PennDOT e-Notification No. 50

Interim Revision to Bridge Standard Drawing(s)	Precast Concrete Substructure Standards, PennDOT Drawing 12-603-BDTD, March 18, 2013 (New Product No. 56), Sheets AS-1 thru AS-5, incorrect Bridge Approach Slab thicknesses in multiple details replaced with a note.
--	---

PennDOT e-Notification No. 54

PennDOT e-Notification No. 55

SECTION D-D:
LONGITUDINAL JOINT OPTION 1

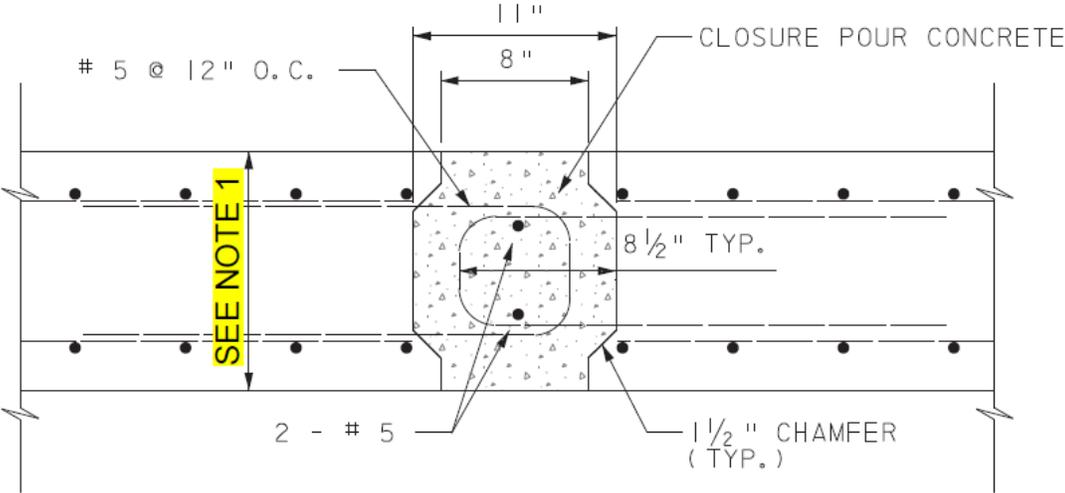
Shts. AS-1 & AS-2 - SECTION D-D (OPTIONS 1 & 2), B-B, E-E & F-F: replaced approach slab thickness of 13” with “SEE NOTE 1” or “SEE NOTE 2” and added the statement shown below as a note on the right hand side of the sheets.

APPROACH SLAB THICKNESS IN ACCORDANCE WITH BD-628M OR A SMALLER THICKNESS MAY BE USED IF CONFIRMED BY DESIGN COMPUTATIONS WHICH TAKE INTO ACCOUNT THE HIGHER CONCRETE STRENGTH OF PRECAST CONCRETE.

END OF APPROACH SLAB WITH NEOPRENE
STRIP SEAL DAM ADJACENT TO FLEXIBLE PAVEMENT

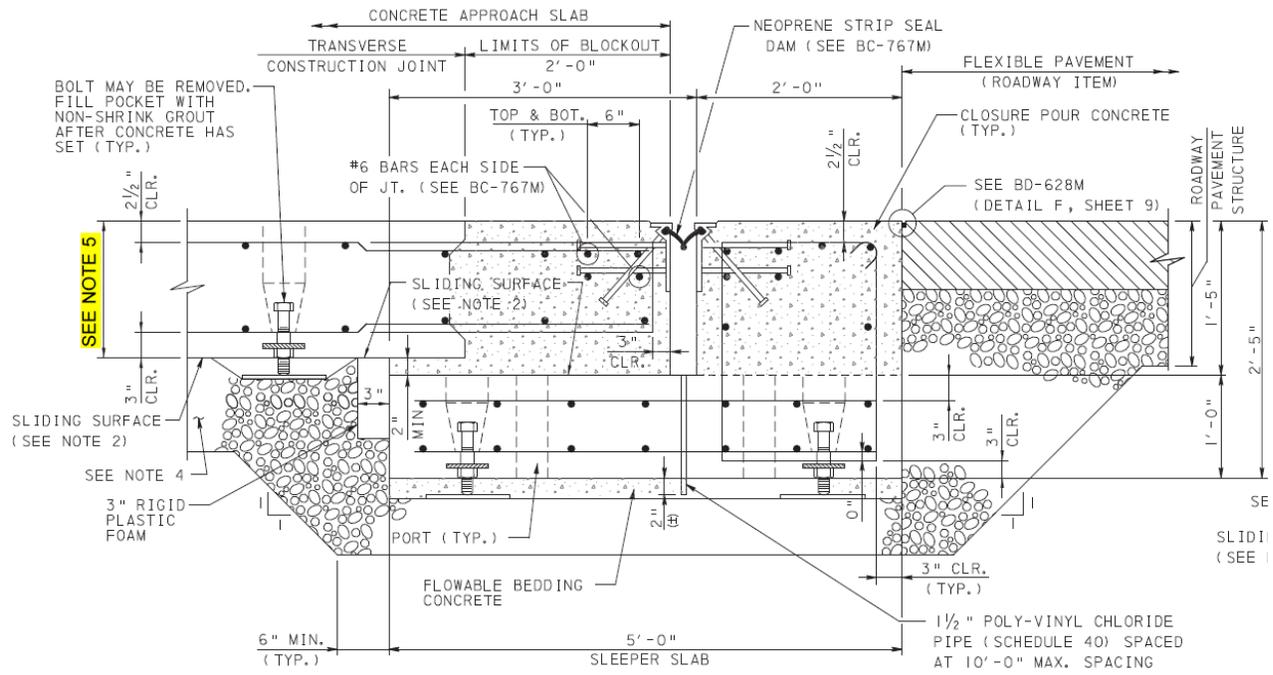
Shts. AS-3 & AS-4 – SECTIONS A-A: replaced approach slab thickness of 1’-3” with “SEE NOTE 5” and added the statement shown below as a note on the right hand side of the sheets.

DETAIL 2 & DETAIL 3 to have similar correction

**SECTION A-A
SLEEPER SLAB - DETAIL 3**

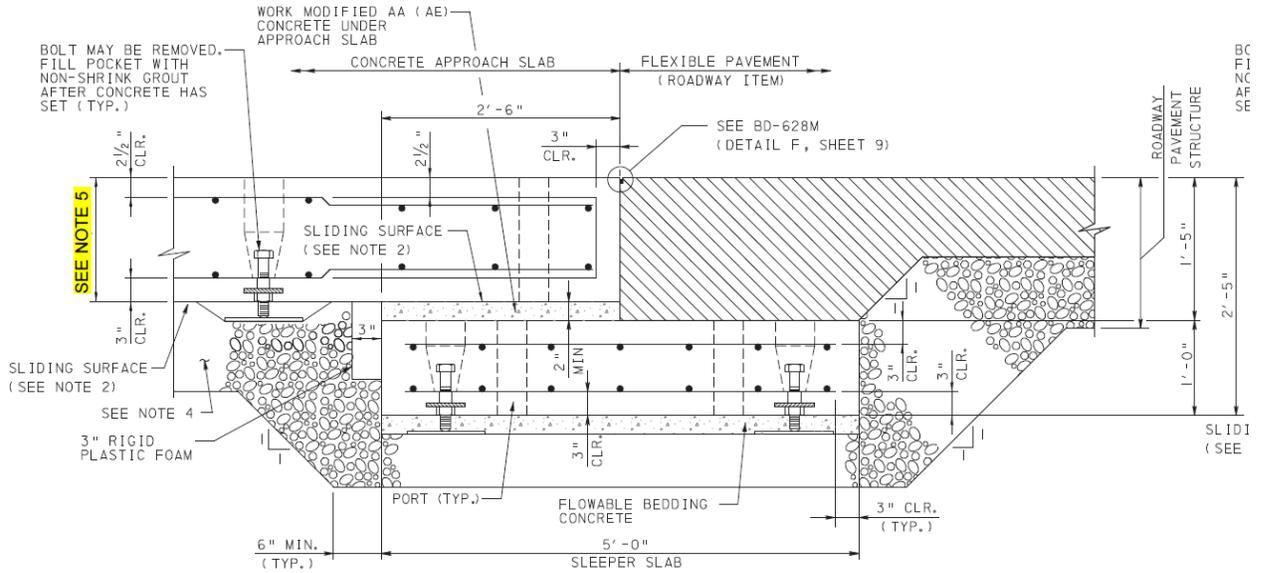
DETAIL 4 & DETAIL 5 to have similar correction

**SECTION A-A: TYPICAL LONGITUDINAL
APPROACH SLAB DRAIN**

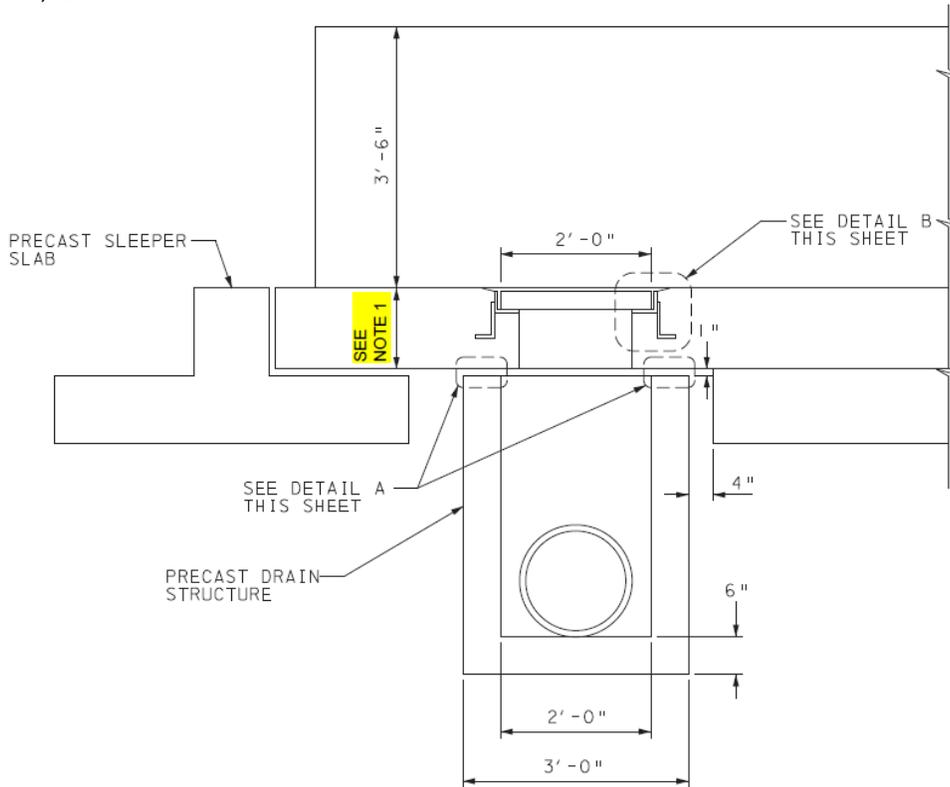
Sht. AS-5 - SECTION A-A & TYPICAL TRANSVERSE SECTION: replaced approach slab thickness of 13” with “SEE NOTE 1” and added the statement shown below as a note on the right hand side of the sheet.

WINGWALL SECTION D-D

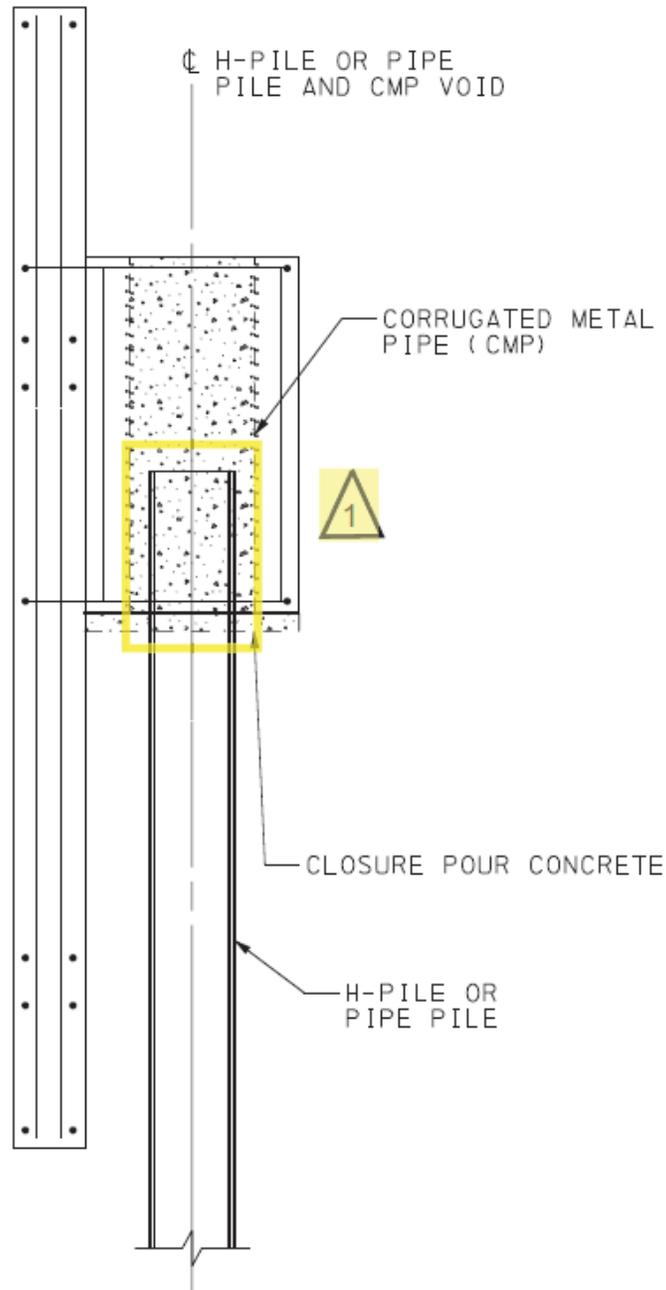
Sht. IA-2 - NOTES: Added Note 4: REFER TO SHEET IA-5 FOR DETAILS OF PILE CONNECTION IN PRECAST PILE CAP FOR INTEGRAL ABUTMENT. This addition has a Rev.1 triangle placed next to it.

Sht. IA-2 – WINGWALL SECTION D-D: removed indication of the 8 rebars or studs in the top of the pile which is located within the corrugated metal pipe. Also, removed 1'-0" MIN. pile insertion dimension.

H-PILE CONNECTION TO PILE CAP

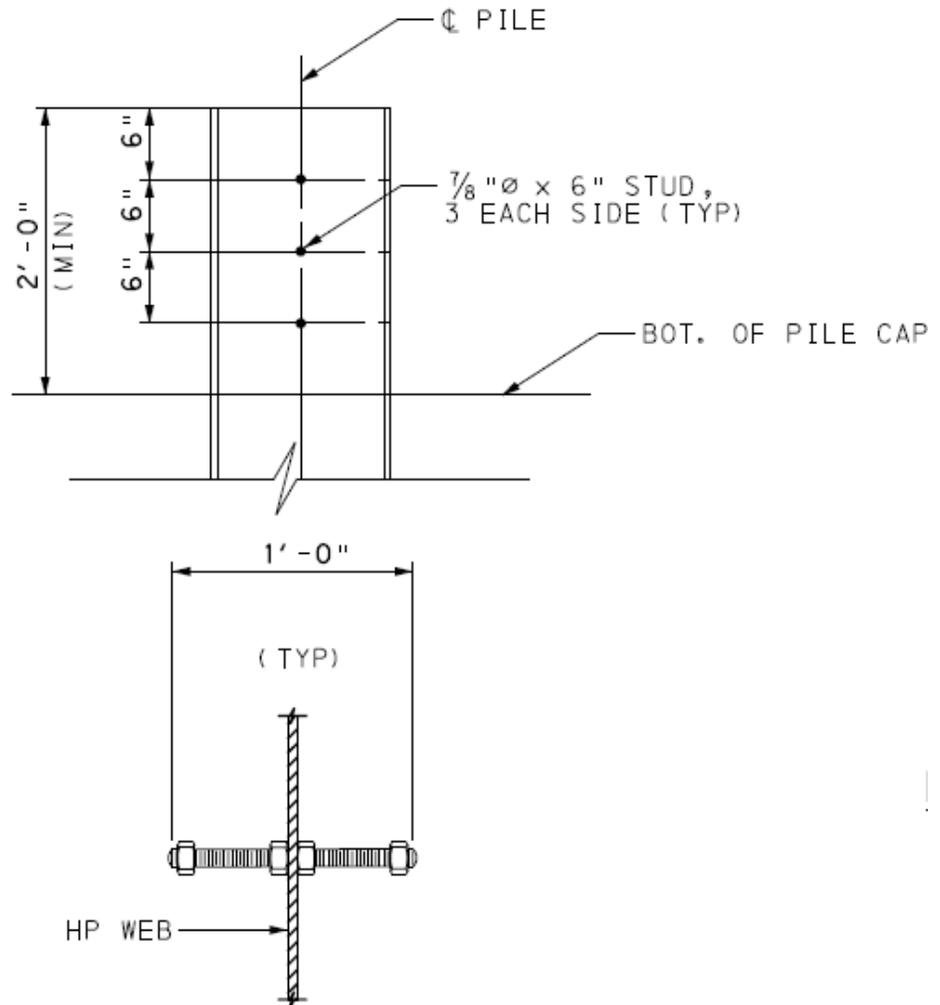
Sht. IA-5 – Pile Connection to Pile Cap Details: added H-PILE CONNECTION TO PILE CAP and PIPE PILE CONNECTION TO PILE CAP details both indicate a 2'-0" MIN. insertion of pile into pile cap. (see attached sheets).

e-Notification No. 74, BD-624M, Sheet 2 – Correction of construction joint referenced in concrete call-outs:

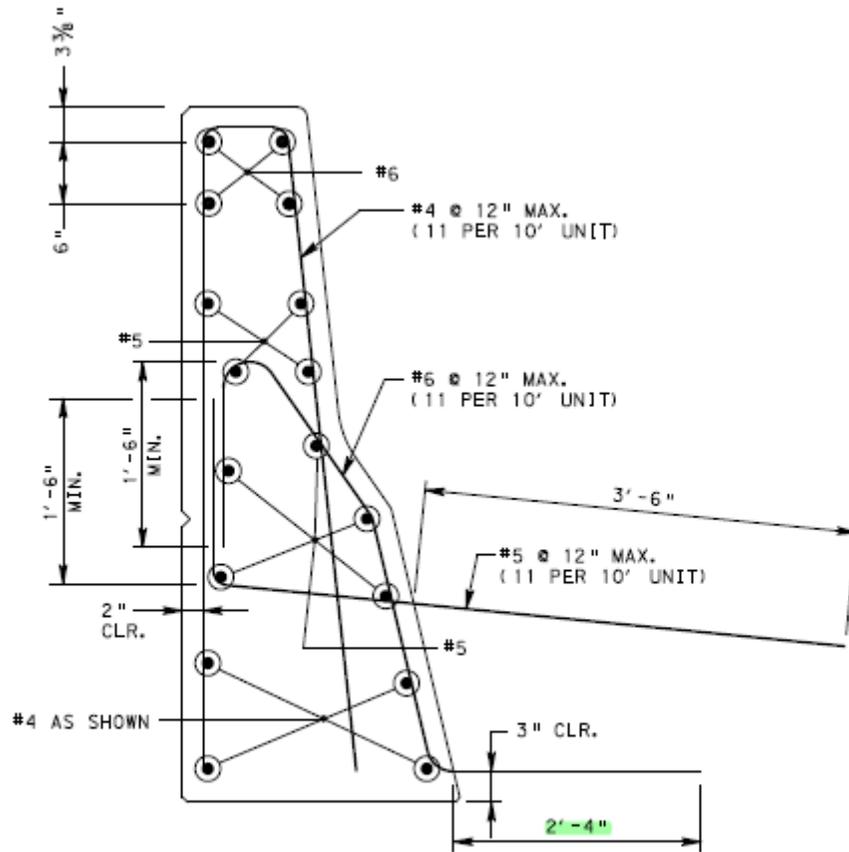
BD-624M, Sheet 2 – SECTION C-C and ALTERNATE SECTION C-C: In the call-out of the class of concrete to be used in the lower portion of the flared safety wings, correct "VERTICAL CONSTRUCTION JOINT" to "HORIZONTAL CONSTRUCTION JOINT".

~~**SKEW ANGLE < 75 DEGREES OPTION 2**~~
SQUARED JOINT OPTION (ALL SKEW ANGLES)

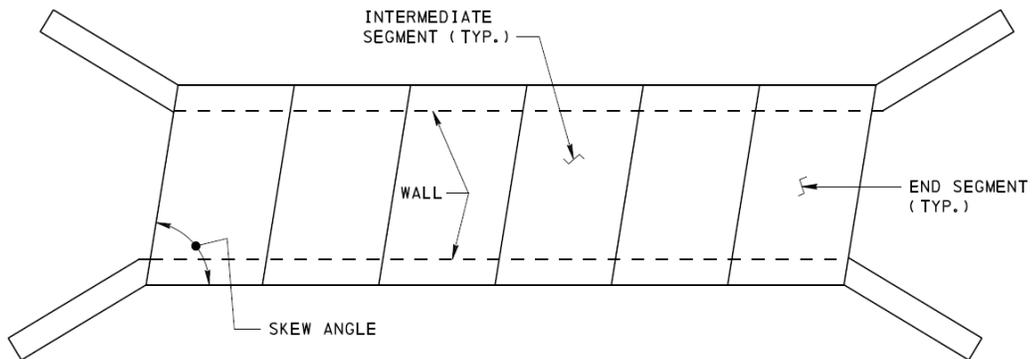
SKEW ANGLE < 75° - OPTION 2 detail: Renamed detail “SQUARED JOINT OPTION (ALL SKEW ANGLES)”.

SKEWED JOINT OPTION
SKEW ANGLE ≥ 75 DEGREES

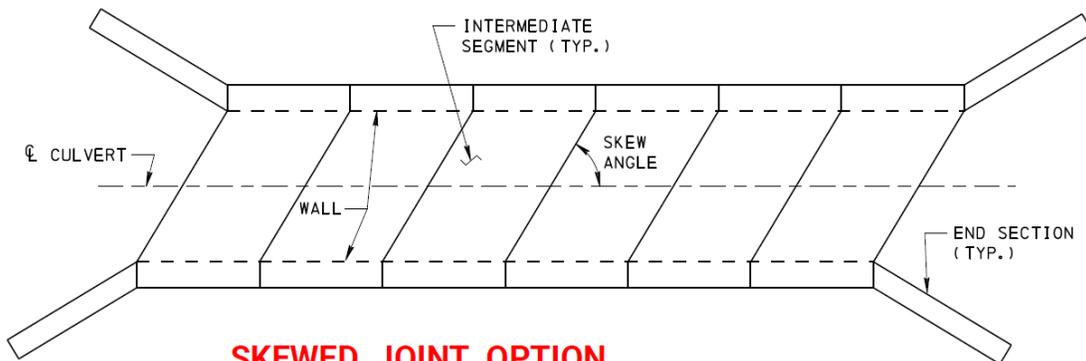
SKEW ANGLE ≥ 75° detail: Added “SKEWED JOINT OPTION” to detail name.

SKEW ANGLE < 75° - OPTION 1 detail: Added “SKEWED JOINT OPTION” to beginning of detail name and removed “- OPTION 1”.
